STATE OF WASHINGTON DEPARTMENT OF ECOLOGY

Re: PD-16-00001 and LP-17-00004

Thank you for the opportunity to comment during the optional determination of nonsignificance process for the rezone of 4.47 ac parcel to a Planned Unit Development and divide the 4.47 acres into 34 lots. This project is proposed by MDJ Contractors, LLC. We have reviewed the documents and have the following comments.

Orange area is approximate location of property boundaries. Not sure about northern extent.

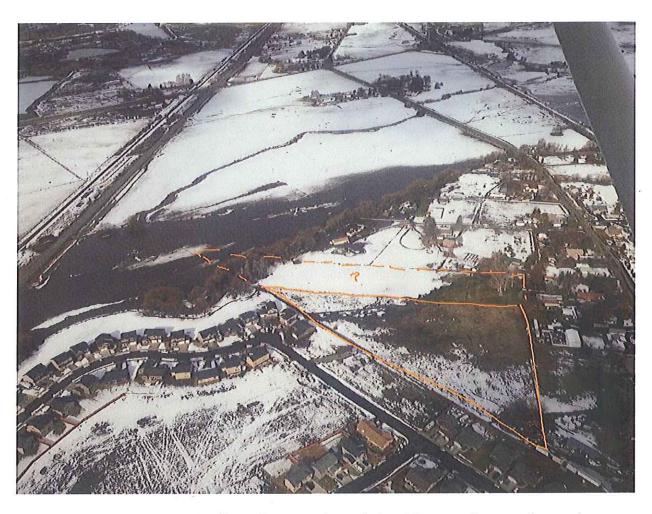
Wetlands provide important flood attenuation and water quality treatment and any wetland areas on or adjacent to the site should be protected under applicable local, state and county wetland regulations. Since the project area is subject to natural flooding patterns (see aerial photo below provided to Ecology by WA Dept. of Fish and Wildlife) and because of the project area's proximity to Currier Creek, any wetlands that are found to be present on site would be subject to GMA regulations, and should be protected or mitigated in accordance with Best Available Science.

Adequate stormwater and flood retention capability should be set aside on site. This is needed in order to protect adjacent wetlands and the water quality of Currier Creek and other downstream waters.
